# SERVICE BULLETIN

Feb. 15, 2000

**FOR ALL BASS  
FISHING U/R  
GAMES**

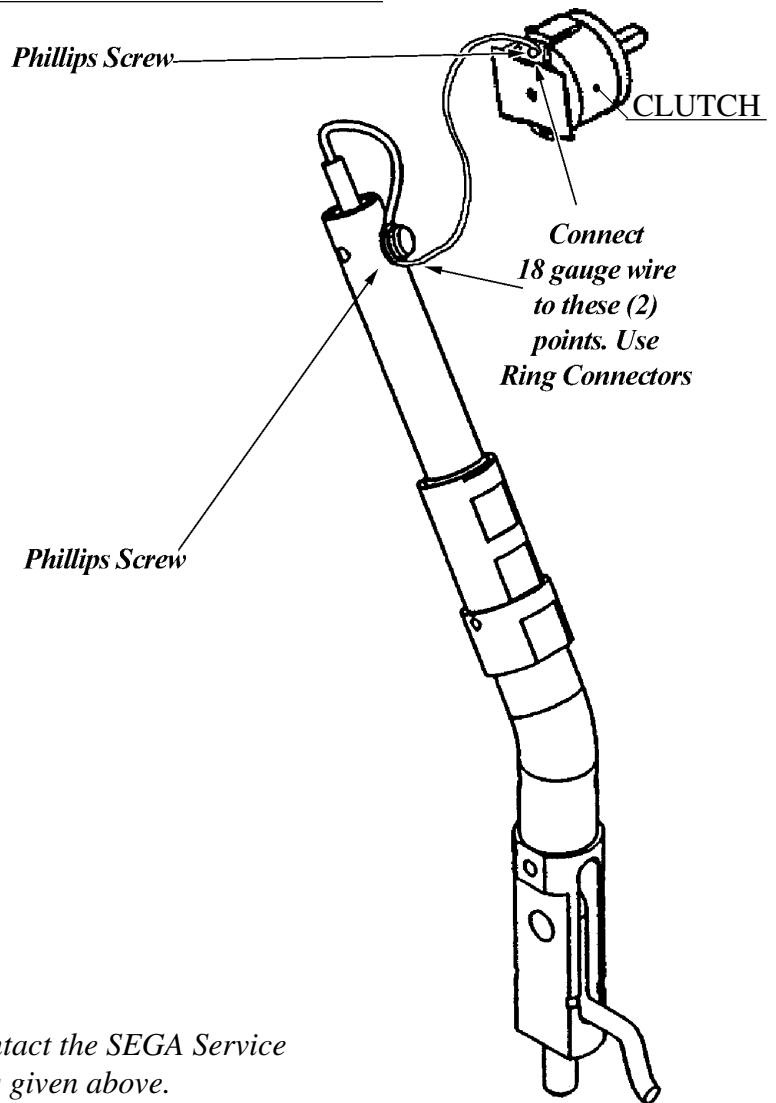
**Problem:** Reel encoder becomes disfunctional.

**Cause:** Excessive static being discharged into control handle can damage encoder.

**Solution:** To help control this, a second ground wire (18 guage) can be added to the handle assy (see diagram below) . Also, the use of an extension cord for main power should be avoided. The outlet that the machine is plugged into needs to be properly grounded, use Recepticle (plug polarity) Tester to verify. (Grainger Part No. 3T885) *or equivalent.*
